From: Rob Wilson
To: "Kirsten Dell-Hartgers"; Garry Van der Krogt
Cc: Margaret Waller; Les Wilson
Subject: RE: Cashmere High - id 340 - monthly fire alarm and sprinklr testing
Date: Monday, 11 February 2019 6:21:37 p.m.
Attachments: [REDACTED]

Subject: Fire Systems failures

Response to building warrant fitness inspection by Argest on 20 June 2019.

FIRE ALARM SYSTEM
S BLOCK
FIRE ALARM SYSTEM

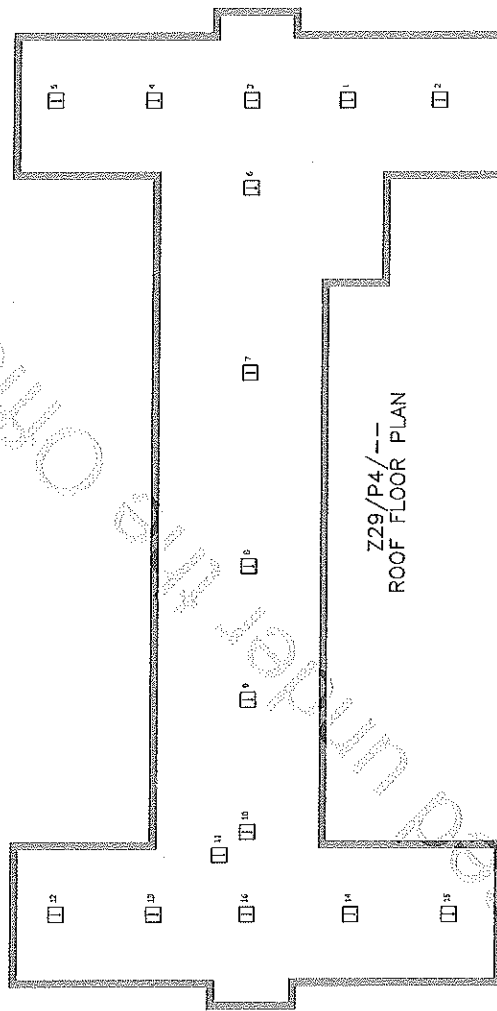
Looking at S block asbuilt the logical location would be in the callpoint in the stairs.

SITE PLAN

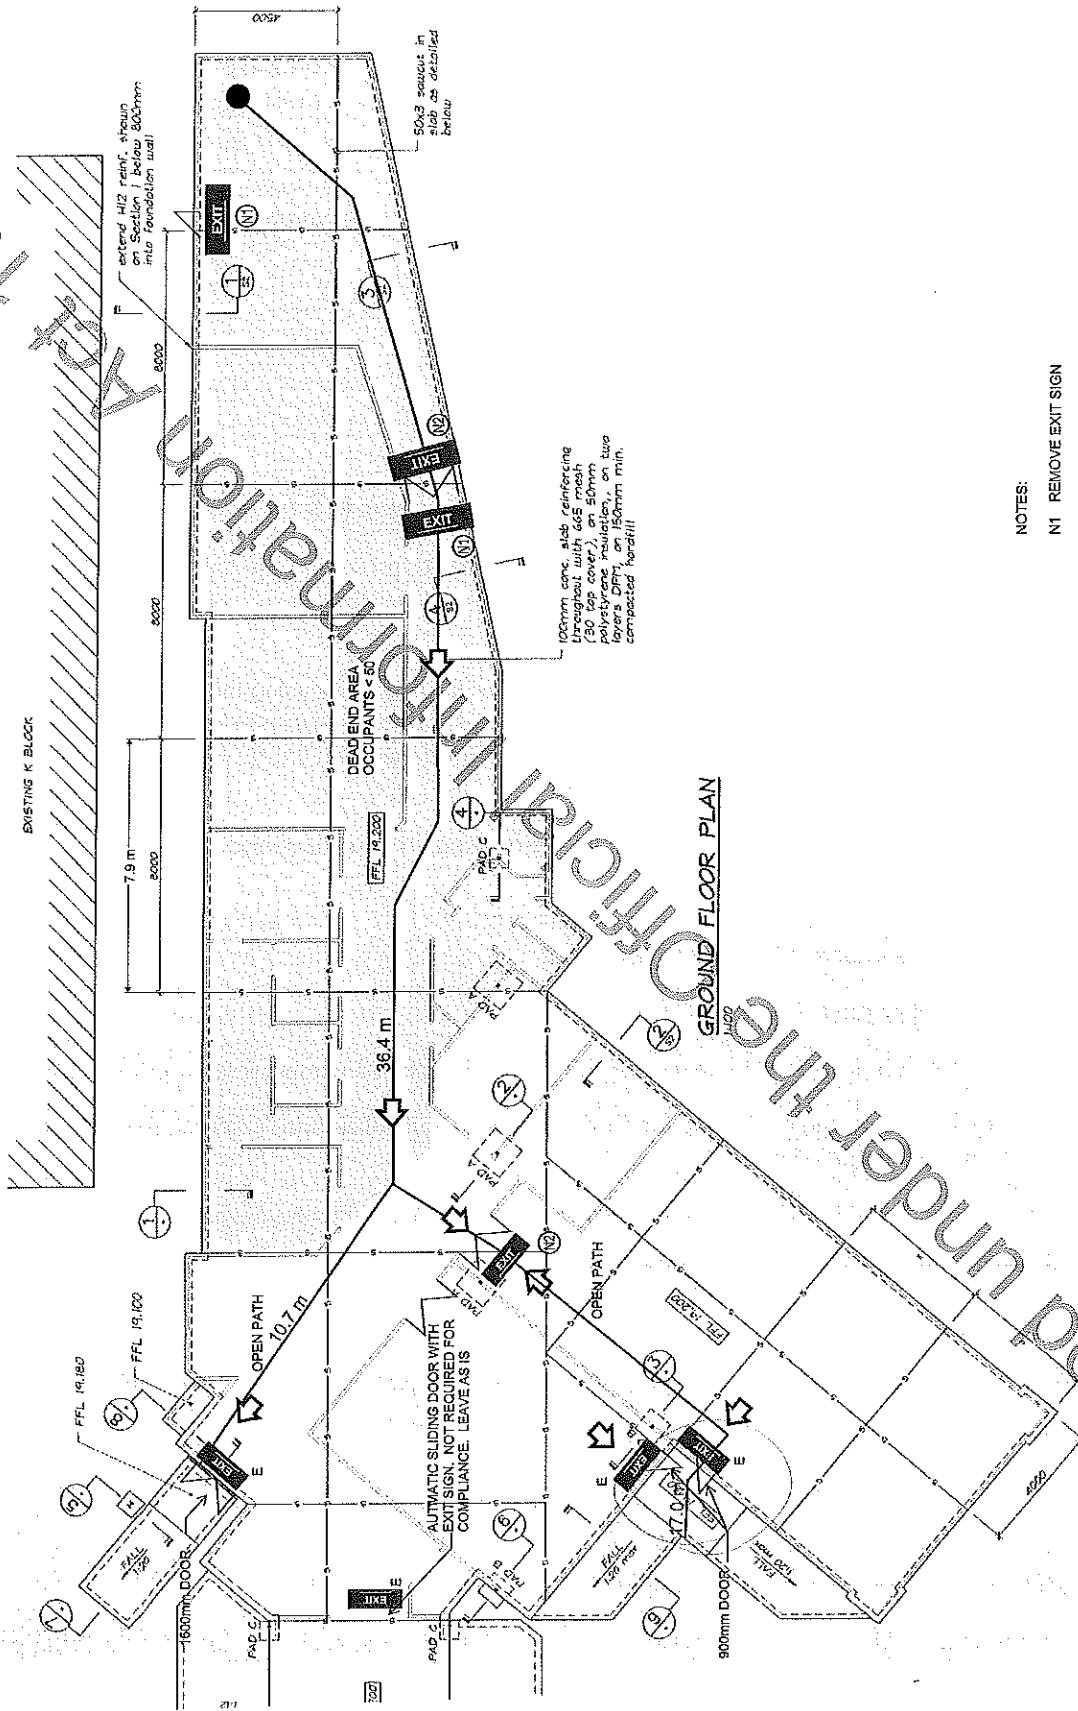
1. Add new EXIT sign above door in Classroom 2 into circulation space. Sign can be of the photo-luminescent type
2. Remove EXIT sign above door in circulation space into resource room
3. Add new EXIT sign above door in resource room into circulation space. Sign can be of the photo-luminescent type
4. Remove EXIT sign above final exit door in resource room.

- NOTES:
- N1 REMOVE EXIT SIGN
 - N2 PROVIDE EXIT SIGN OF PHOTO LUMINESCENT TYPE
 - E EXISTING EXIT SIGN TO REMAIN

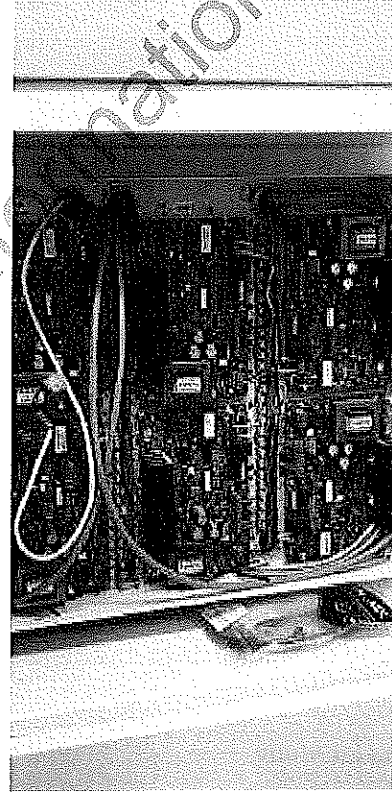
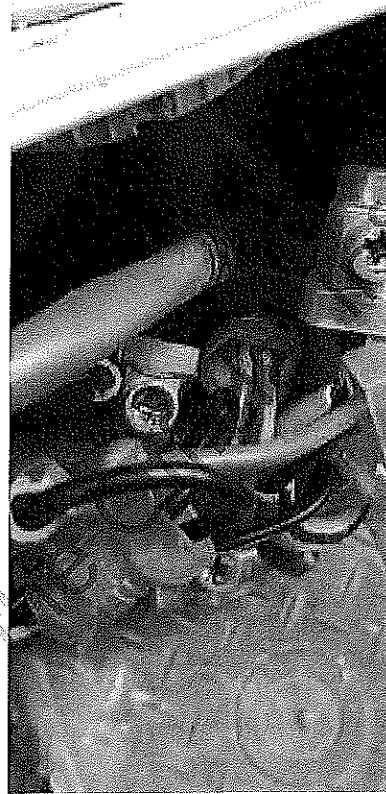
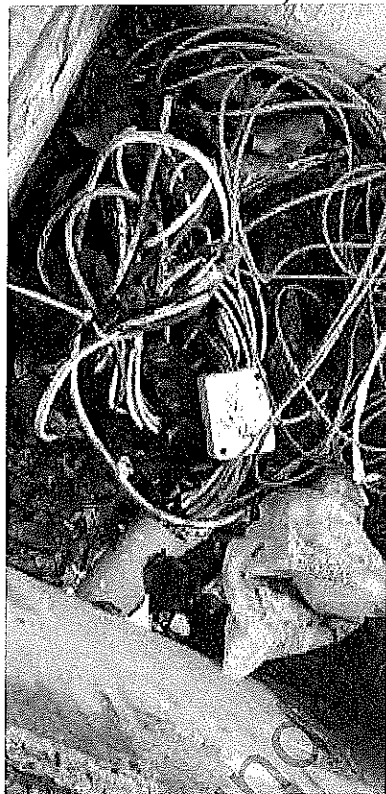
5. Sounder fault on Amp 4 needs attention as this is causing a fault on the panel
We carried out fault finding on evacuation circuit for Amplifier 4. The fault tended to come and go. We tracked it back to some underground junctions that were inadequately terminated. These junctions were temporarily made good and the fault cleared. No sign of a fault on this Amplifier has since occurred. The temporary junction will not cause issue but will require a permanent water protected join which we will look at doing week starting 15 July 2019 during School Holidays. Photo 1 shows underground junction with inadequate water protected terminations. Photo 2 shows another major junction on the side of the Administration Block which also required improved terminations. Photo 3 shows ALL Amplifiers in normal state (defect state shows a bright yellow LED on the left of the board).
